Submission of Further Information

Proposed Temporary Place of Recreation, Sports or Culture (Indoor and Outdoor Recreation Centre) and Animal Boarding Establishment with Ancillary Facilities for a Period of 3 Years and Associated Filling of Land in “Agriculture” Zone, Lot Nos. 1486 (Part) and 1489 (Part) in D. D. 107 and Adjoining Government Land, Kam Tin, Yuen Long, New Territories (S.16 Planning Application No. A/YL-KTN/991)

Comments from Drainage Services Department dated 7.6.2024

Goldrich Planners & Surveyors Ltd.
Plan 7.2a
(P 20039)

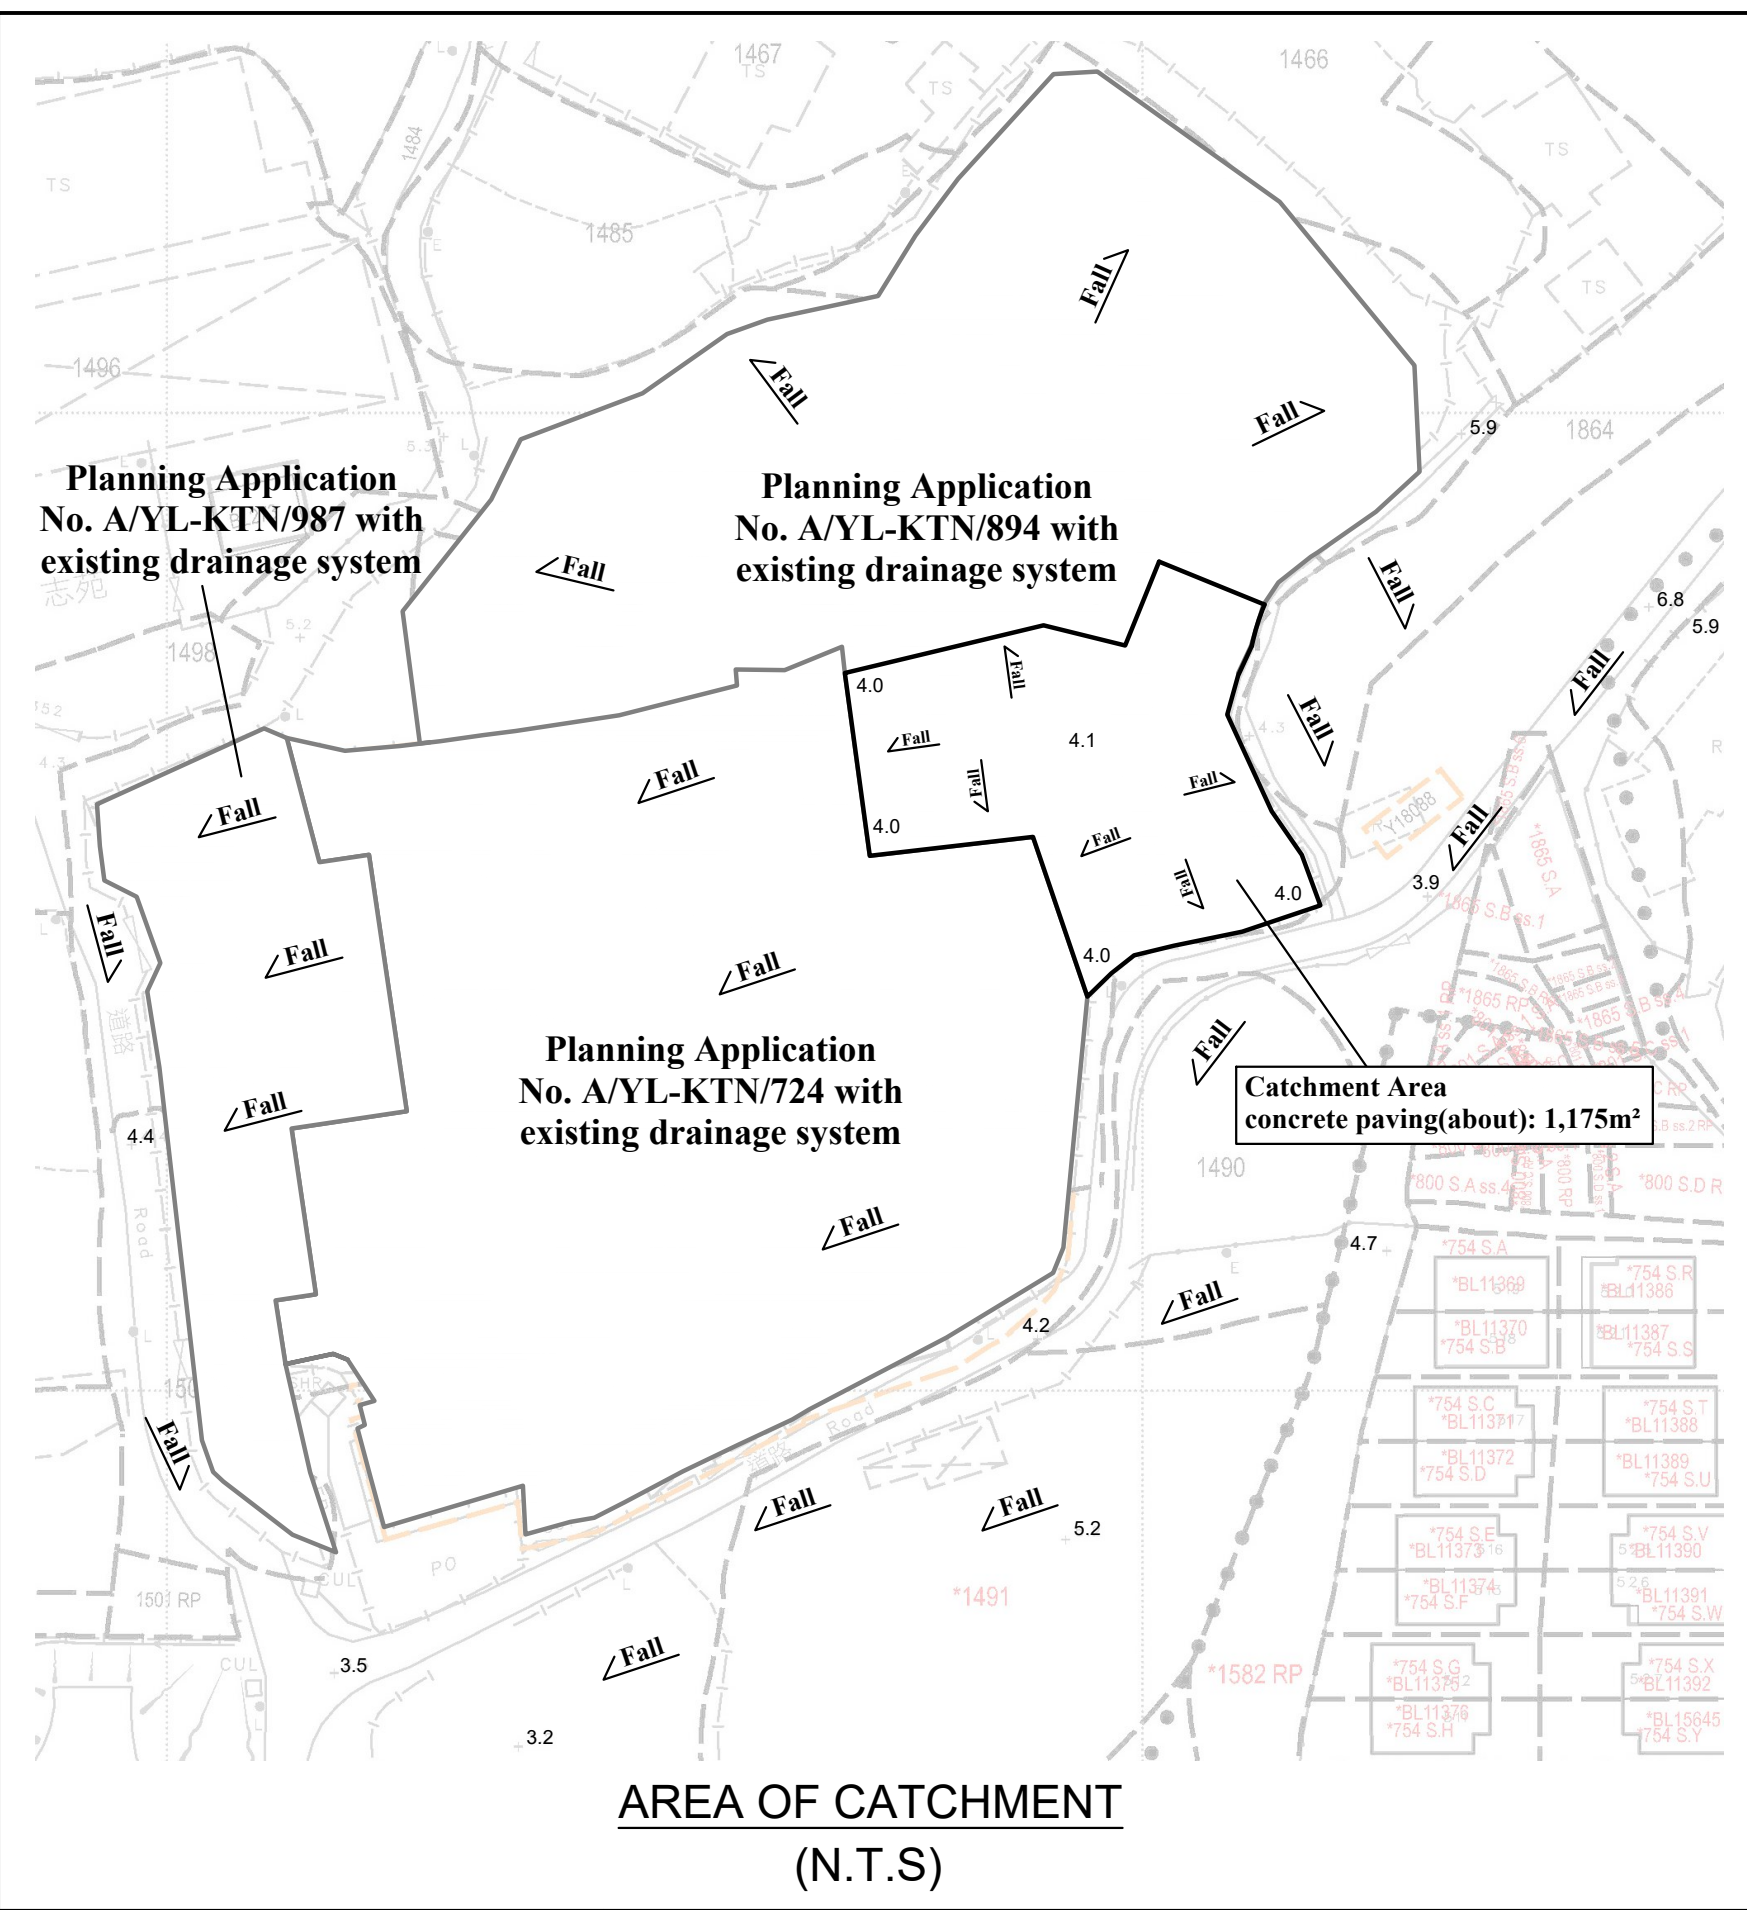
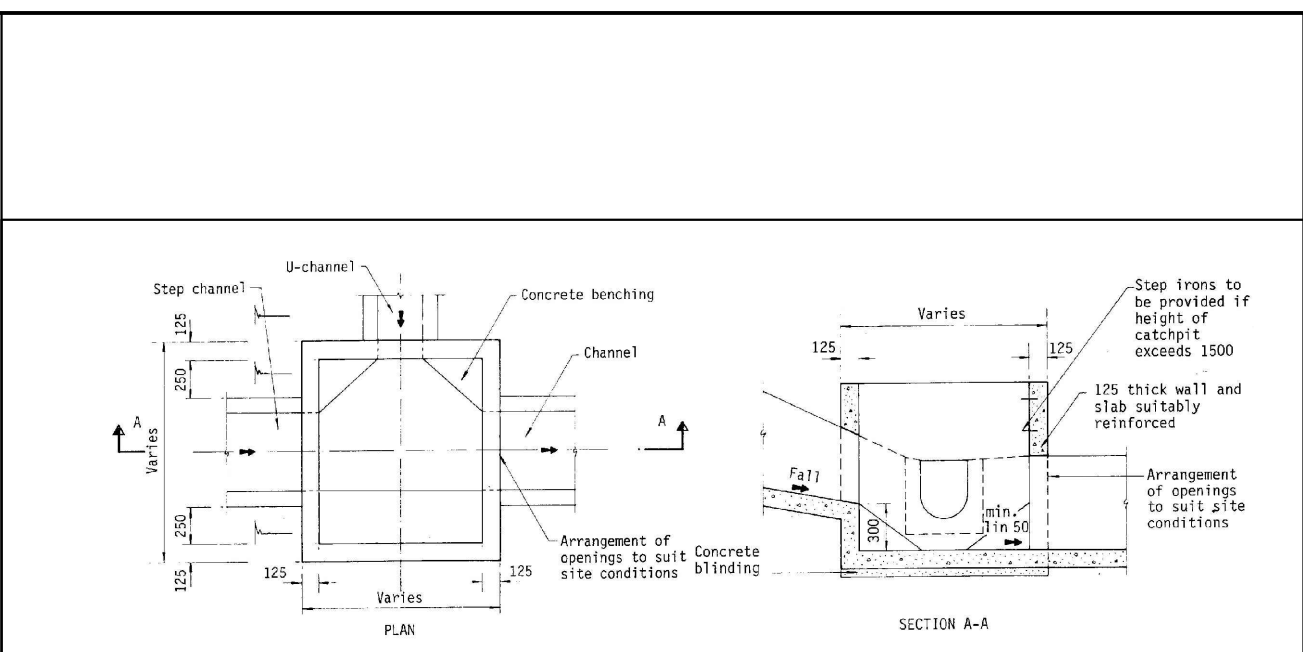
2.	Please demonstrate with hydraulic calculations, with catchment plan, that all proposed/ existing drainage facilities are adequate to collect, convey and discharge the surface runoff accrued on the application site and to intercept the overland flow from the adjacent lands. External catchment areas should also be included in the assessment.	<p>To the west, there is another planning application no. A/YL-KTN/724 which has its drainage facilities to collect the surface runoff.</p> <p>To the north, there is another planning application no. A/YL-KTN/894 which has its drainage facilities to collect the surface runoff. Majority of the site area there is grassland. Surface runoff flows to the north into the existing ditch.</p> <p>To the east, the surface runoff flows to the east and south to the local track at the south which will not flow to the application site.</p> <p>At the south, the ground level of the local track is lower than the subject site.</p> <p>To the further south east, the residential development has its own drainage system.</p> <p>Therefore, no surface runoff flows to the application site from the surrounding area. Please refer to Plan 7.2a for the catchment area.</p>

Viewpoint 1

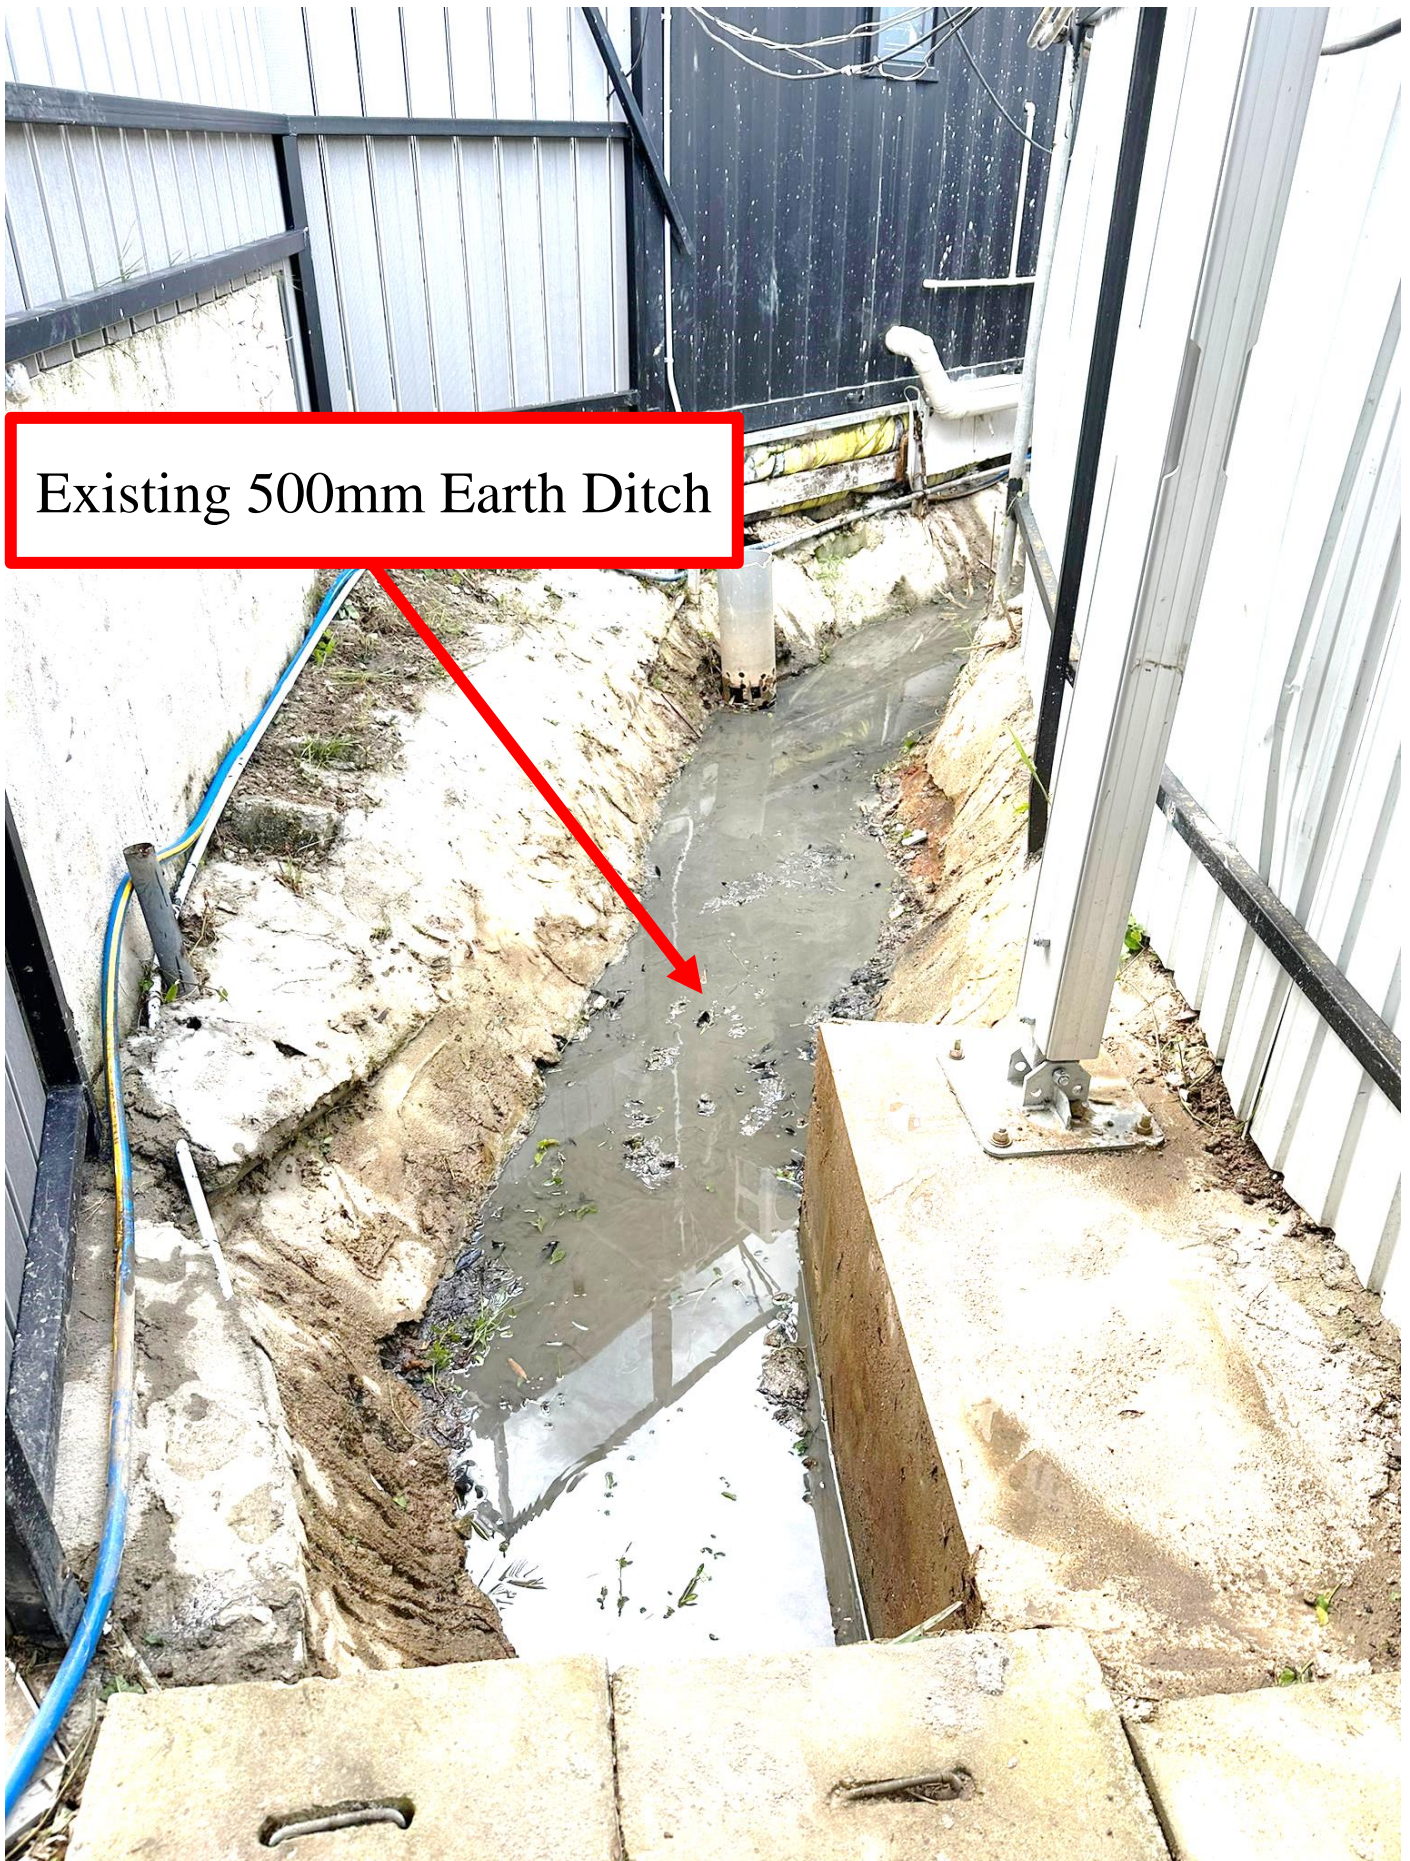
5.	The applicant should check and ensure the hydraulic capacity of the existing drainage facilities would not be adversely affected by the captioned development. Please provide site photos to show existing condition of the existing drainage facilities which receives the discharge from the application site, and demonstrate the existing drainage facilities (i.e. DSD existing 450mm and 600mm dia. pipes) have spare capacity to cater for the additional discharge, if any, from the proposed development.	<p>There are existing drainage facilities at the southern, western and northern side of the site. No flooding has been reported for the past years. It is expected that the existing drainage facilities on site would not affect the existing condition of the nearby drainage facilities.</p> <p>Please refer to the attached site photographs showing the existing condition of the existing drainage facilities which receives the discharge from the application site.</p>
